SNOW ROAD SUBDIVISION

APPLICATION NUMBER 11 DATE January 3, 2013
APPLICANT Snow Road Subdivision
REQUEST Subdivision

DETAIL SITE PLAN

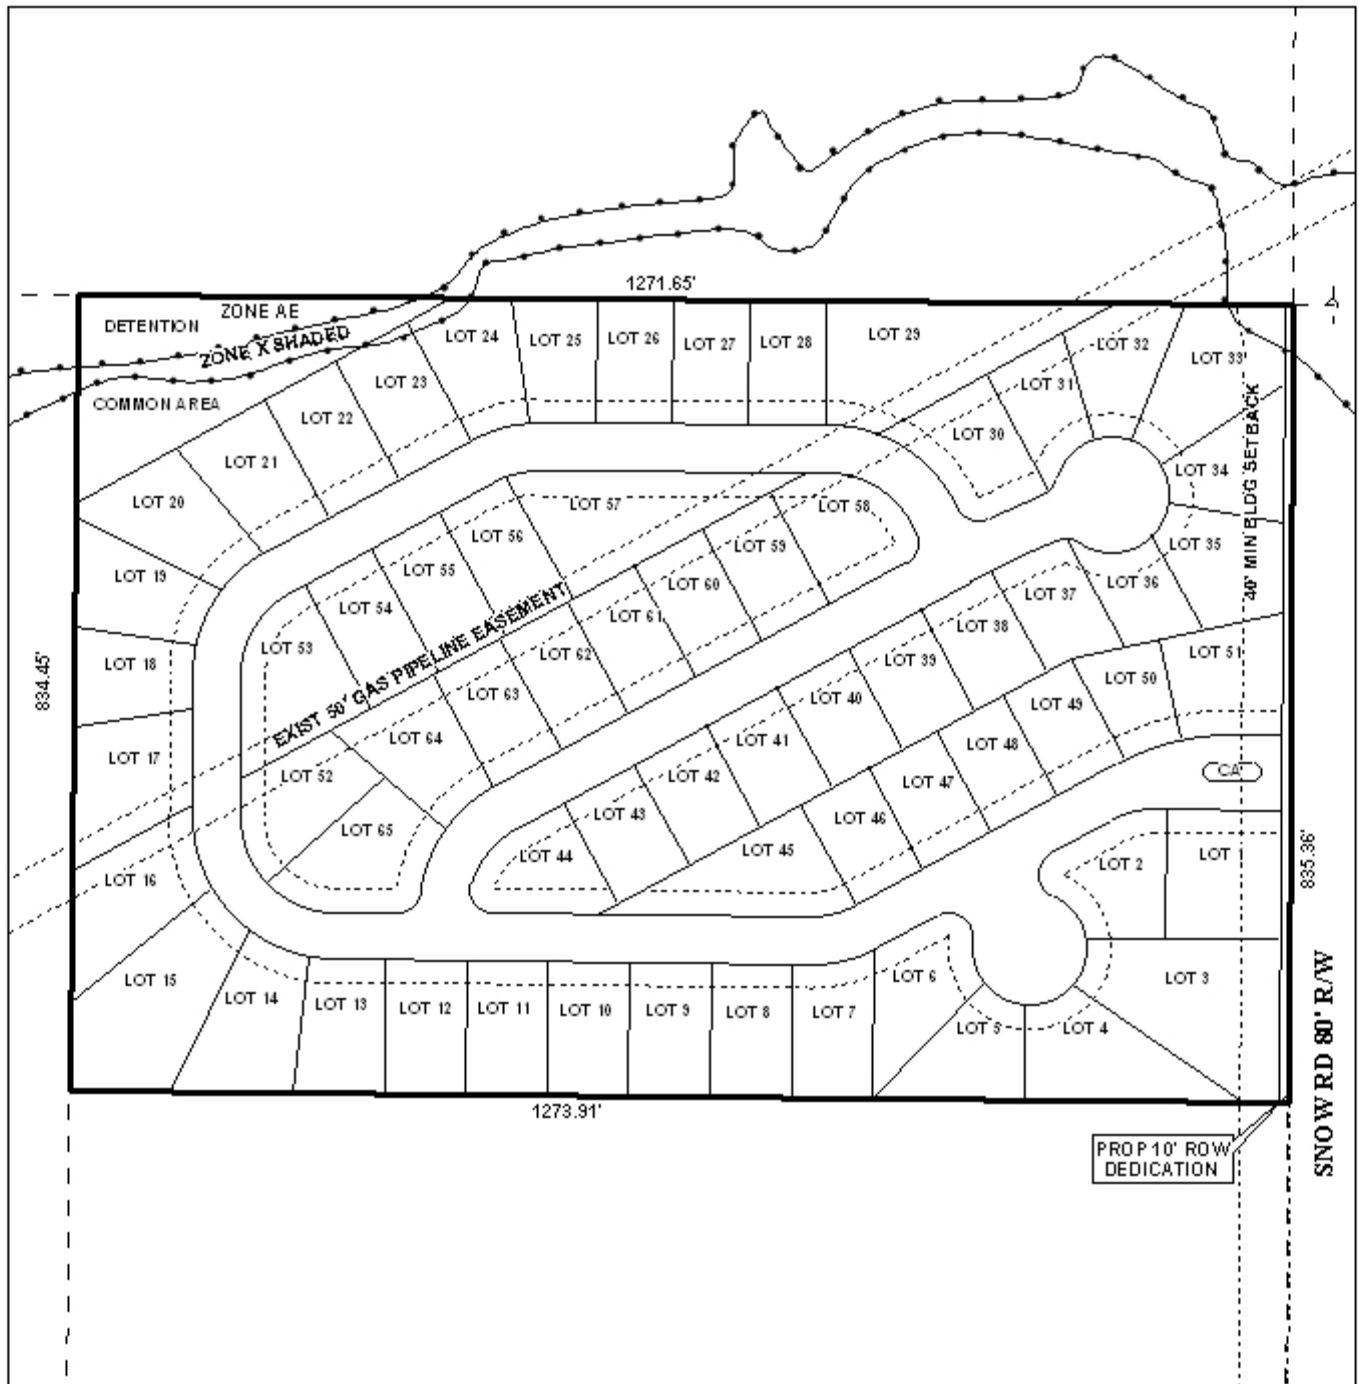
It should be noted that the site abuts a land-locked parcel to the West. Section V.B.1. of the Subdivision Regulations require the provision of street-stubs to adjacent properties, therefore the plat should be revised to depict the provision of one street-stub to the land-locked property to the West.

As designed, six lots will have frontage onto streets internal to the proposed subdivision as well as frontage onto Snow Road. To minimize the number of curb-cuts onto Snow Road, lots with

double frontage should be denied direct access to Snow Road. All lots within the development should be limited to one curb-cut, with the size, design and location to be approved by Mobile County Engineering, and to comply with AASHTO standards.

All lots appear to meet minimum size requirements for properties served by public water and sewer systems. Additionally, the 25-foot minimum building setback line is depicted on the preliminary plat, however, the plat should be revised to additionally depict it along the rear of Lot 43, where it is within 25-feet of Street "B."

An existing 50-foot wide waterline easement along Snow Road creates a minimum 40-foot building setback for those lots with rear frontage onto Snow Road. A second easement, a 50-foot wide gas line easement, cuts diagonally across the site, which is accommodated along rear or side lot lines. A detention common area is depicted on the plat, but no drainage easements are depicted to the common area: the plat should be revised to depict an access easement to the proposed detention facility, and any other drainage or utility easements which may be required as part of the development. A note should be placed on the plat stating that no permanent structures may be placed in any easement.

The proposed detention area includes Zone AE and X-shaded flood zones. The applicant should ensure that the location of any detention facility complies with Mobile County Engineering requirements.

Common areas are proposed for the site. A note should be placed on the plat stating that maintenance shall be the responsibility of the property owners.

- 1) Provision of a street-stub to the property abutting the site to the West;
- 2) Provision of a 25-foot setback along the rear portion of Lot 43;
- 3) Provision of an easement to the proposed detention facility from a public street, and depiction of any other drainage or utility easements which are anticipated for the development; and
- 4) Revision of lot size and other plat information based upon the provision of the requested street stub.
